**DESIGN MEMORANDUM 1
GENERAL DESIGN**

**MURRELLS INLET NAVIGATION PROJECT
GEORGETOWN COUNTY, SOUTH CAROLINA**

**REVISION OF
WEIR SYSTEM AND
JETTY & CHANNEL ALIGNMENTS**

SUBJECT: Murrells Inlet, South Carolina - Supplement No. 1 to the
General Design Memorandum - Revision of Weir System and
Jetty and Channel Alignments

FIGURE 16

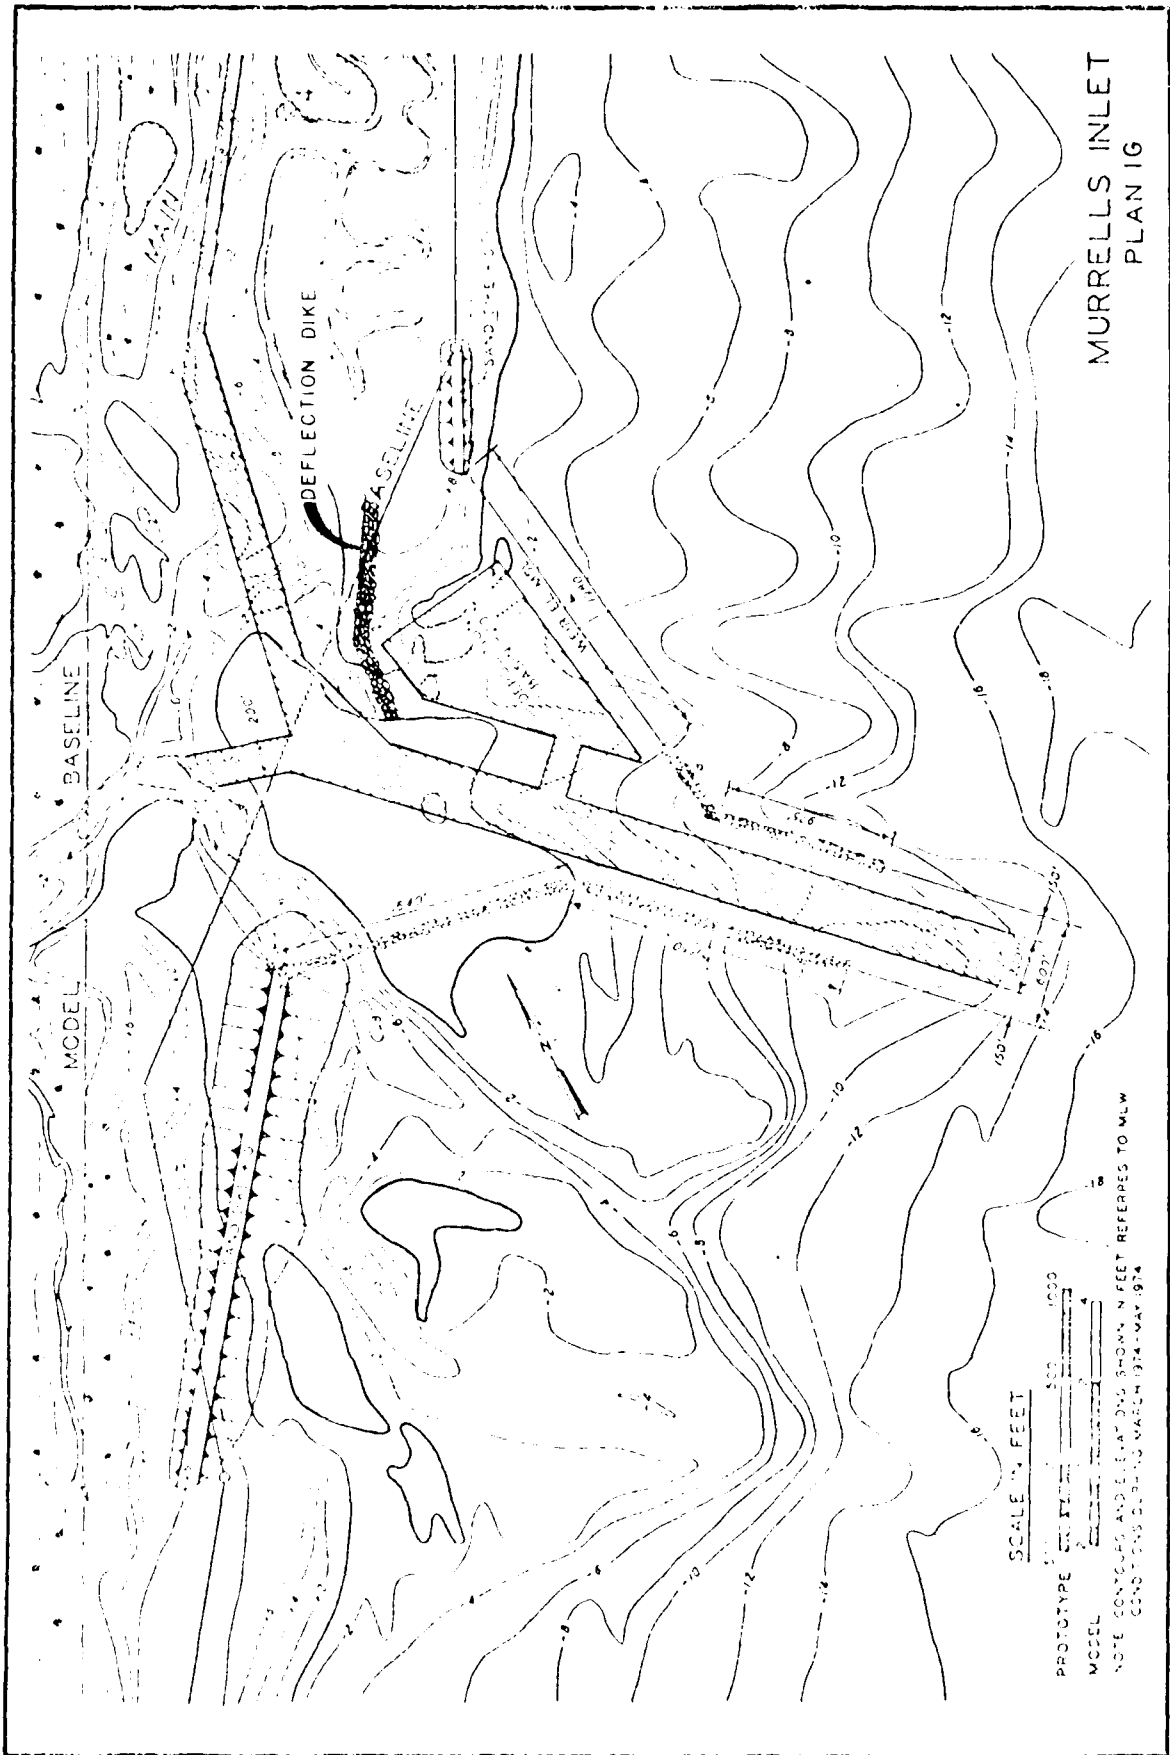
h. Plan 1G. This plan (Figure 16) was essentially the same as Plan 1D but with a 1,300 foot deflector dike added to extend from the Garden City peninsula around the north side of the deposition basin. Its crest elevation remained constant at +9.0 feet mlw along its entire length. Surface current photography showed that the ebb currents were effectively deflected and remained within the dredged channels.

FIGURE 16A

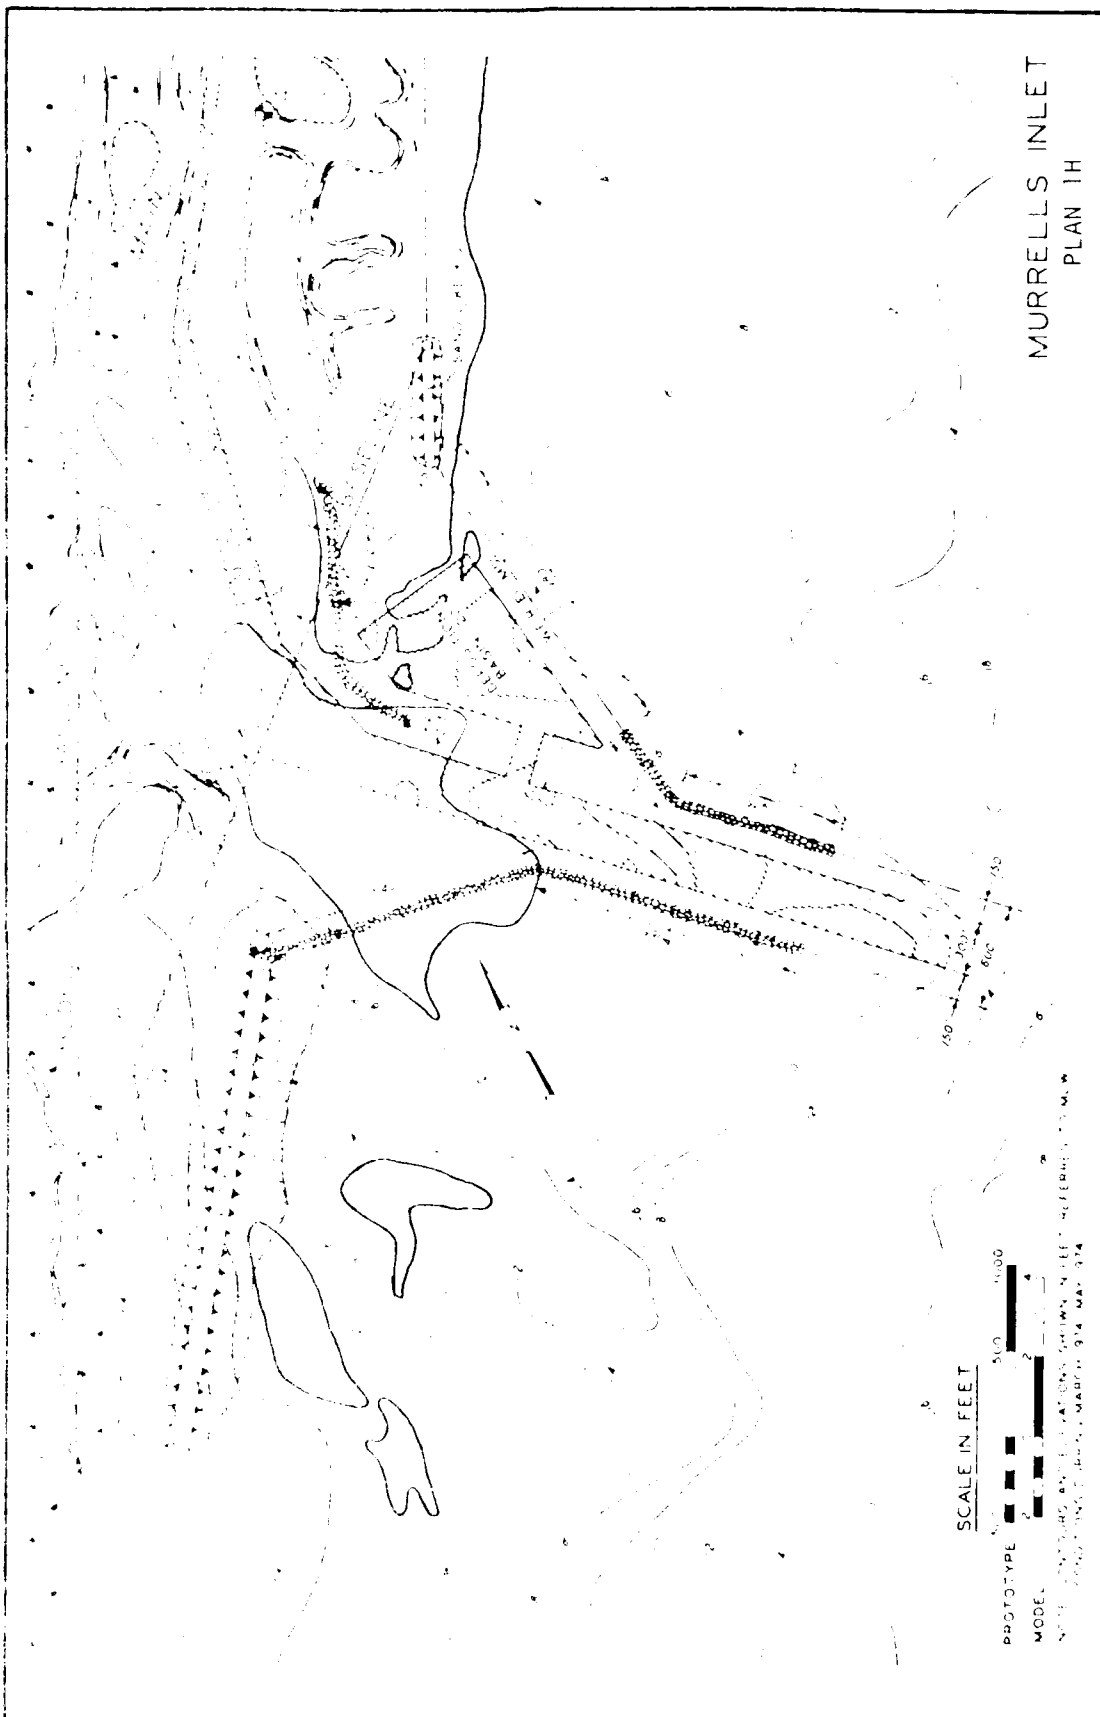
i. Plan 1H. Plan 1H (Figure 16a) was developed to improve hydraulic characteristics through the weir and deposition basin during flood flows. This plan is identical to Plan 1G except that the training dike has a crest of varying elevation. Starting at the dune line, the crest varied from +9.0 feet mlw to +2.3 feet mlw approximately 600 feet from the dune line; thence, remained constant at +2.3 feet mlw to the end of the dike. This plan produced the most favorable results of all the previous model testing.

11. GDM Supplement Plan. At WES' recommendation, Plan 1H has been adopted as the project plan for presentation in this GDM Supplement. However, the District proposes not to construct the deflector dike as a part of initial construction. The reasons for this decision are as follows:

(1) The dike is considered to be an extreme safety hazard to navigation of small boats. Upon entering the inlet from the ocean through the jettied opening, a boat operator would not expect another rock structure to be projecting into the open water and the chance of serious accidents, particularly during periods of darkness or inclement weather, would be very great. A boat operator not following the navigation channel (and many small boat operators do not) may run aground on a sand bar but this would not have any serious effect on his personal safety. The proposed deflector dike would constitute a serious safety hazard and should be proven to be required based on prototype conditions prior to serious consideration of its construction.

(2) The hydrography of the inlet has changed considerably since the model configuration was moulded. Pipeline dredging operations have recently been completed to straighten and deepen the inner channel between the south end of Garden City and the marshland to the west. The new channel is located further northwest (toward the marsh), and therefore further from the southern tip of Garden City than the previous channel. There is considerable ebb flow in the newly dredged channel and there is reason to believe that the water area northwest of the tip of Garden City will shoal significantly due to lower ebb velocities in this area. The hydrography in the weir and deposition basin area has changed (shallowed) significantly since the model was constructed and prototype conditions may well not produce the migrating ebb currents that the model tends to indicate. Prototype conditions may well exist at the time of construction which would obviate the need for a deflector dike of any kind.

12. The District recommends that the project be built without the deflector dike and that the currents be monitored during and following construction to determine if a need exists for a deflector to protect the deposition basin. If determined to be required, a deflector could be designed to suit the then existing conditions and constructed in a short period of time, well in advance of any real channel migrating problems. Therefore, a deflector dike is included as a contingency item, subject to prototype investigations; however, its cost is included as an item of first cost.
